INDIANA DEPARTMENT OF TRANSPORTATION

APPROVED MINUTES

June 19, 2025, Standards Committee Meeting

RE: Minutes from the June 19, 2025, Standards Committee Meeting

E 205-XXXX-01 TEMPORARY CAUSEWAY INDEX AND GENERAL NOTES (proposed new)

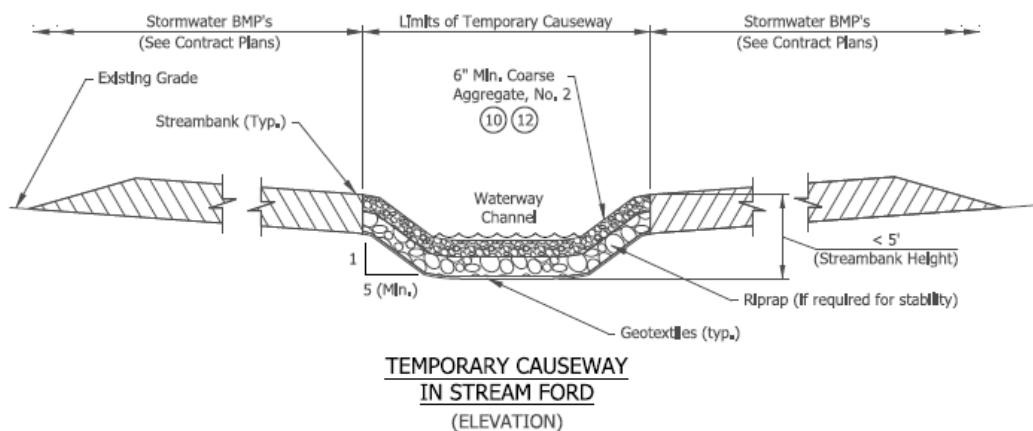
1. The temporary causeway shall remain in place no longer than the time specified in the permits.
2. The Contractor shall confirm that all regulatory requirements are met prior to construction of any crossing.
3. The crossing shall be perpendicular to the stream flow. Spurs constructed parallel to the stream may be acceptable to access other locations. Spurs shall meet the same requirements as the main causeway and shall not create additional restrictions to the flow.

STANDARD DRAWING NO. E 205-XXXX-02

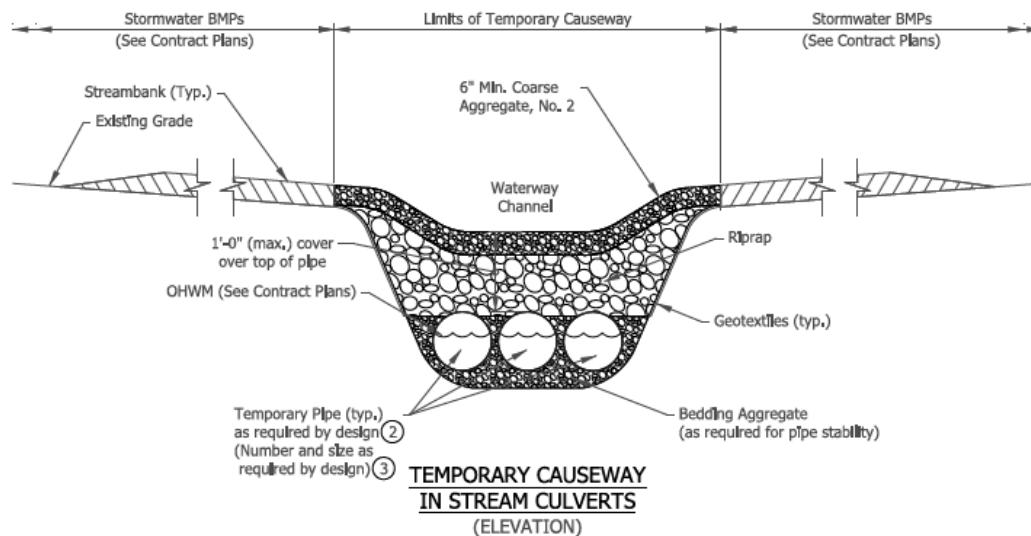
11. All stone above the OHWM shall be placed on geotextiles.
12. The stream channel and stream banks shall be reestablished to the original grades unless otherwise noted on the plans.
